Detailed Site Plan Beltway Plaza Phase 1

DSP-20020

SUBJECT: Detailed Site Plan DSP-20020
Type II Tree Conservation Plan TCP2-030-00-01
Beltway Plaza Phase 1

Figure 1: Phase 1 Overall Site Plan

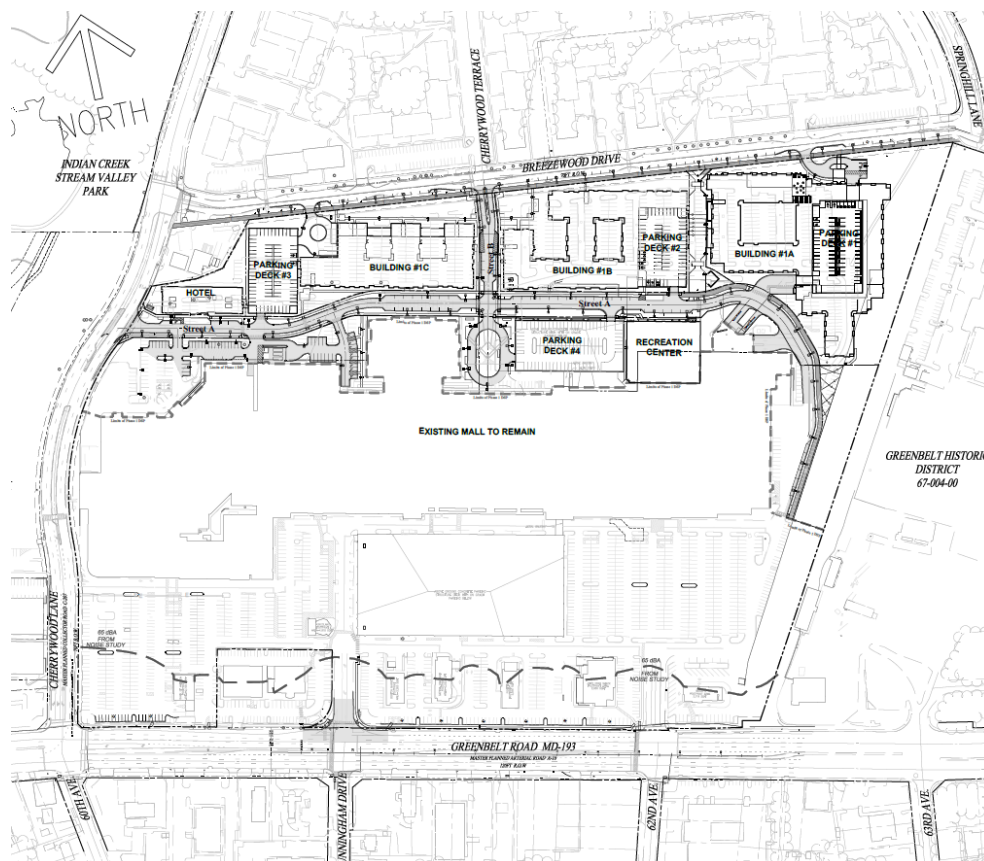
Parking Garage 1 will be fully wrapped by Building 1A. On Parking Garage 2, the western and northern façades will be wrapped by Building 1B, while its eastern and southern façades will be visible from Street A and adjacent buildings. The larger, eastern façade of Garage 2 is proposed to be wrapped with a combination of perforated metal screening with printed images on the upper levels and vegetative screening on its lower levels. The southern façade of Garage 2 does not include screening, and staff recommends a condition for screening treatment to be added in this location.

appropriate technique for improving the appearance of this parking structure. The southern façade of Garage 3 includes an entrance to Street A, but is unadorned and unscreened. Staff recommends that the southern façade of Garage 3 receive a similar treatment to its northern façade. The western elevation of Garage 3 includes vegetative screening on its lower levels and perforated metal screen with printed imagery on upper levels. Portions of the eastern façade of Garage 3, not obscured by Building 1C, are visible to Street A and provides an entrance to Building 1C from Breezewood Drive. These façades are unadorned and unscreened, but highly visible. Staff recommends that visual interest and screening be added to the exposed areas of the eastern façade of Garage 3.

number of parking spaces in this structure. Sheet 1 of the DSP notes 496 spaces, while Sheet 3C shows 479 spaces. A condition has been recommended herein for this discrepancy to be corrected. Vehicular access for Building 1C and its associated parking structure is from Breezewood Drive, at the northwest corner of Building 1C, and from Street A to the south side of the parking structure. Two courtyards with recreational amenities are provided with Building 1C. The eastern courtyard includes grilling stations, seating areas, and sculptures. The western courtyard includes seating areas, a picnic area, a misting pad, a reflecting pool, and lawn areas.

- g. Correct the label for the proposed number of residential units for Building 1A on Sheet 3C of the DSP.
 - h. Provide additional screening, artwork, or other architectural treatments to soften the appearance of the parking structures and add visual interest to the development to the southern facades of Parking Garages 2, 3, and 4, the eastern façade of Parking Garage 3, and northern and western façades of Garage 4. The exact treatment shall be evaluated and approved by the Urban Design Section of the Prince George's County Planning Department.

- i. Correct the number of parking spaces shown for Parking Garage 3 to be consistent throughout the DSP.
- j. Correct Note 1 on the photometric plans, adjust symbology for light poles shown on the DSP, and correct associated lighting details. Details for lighting are shown on Sheet 35, whereas Sheet 36 is referenced.
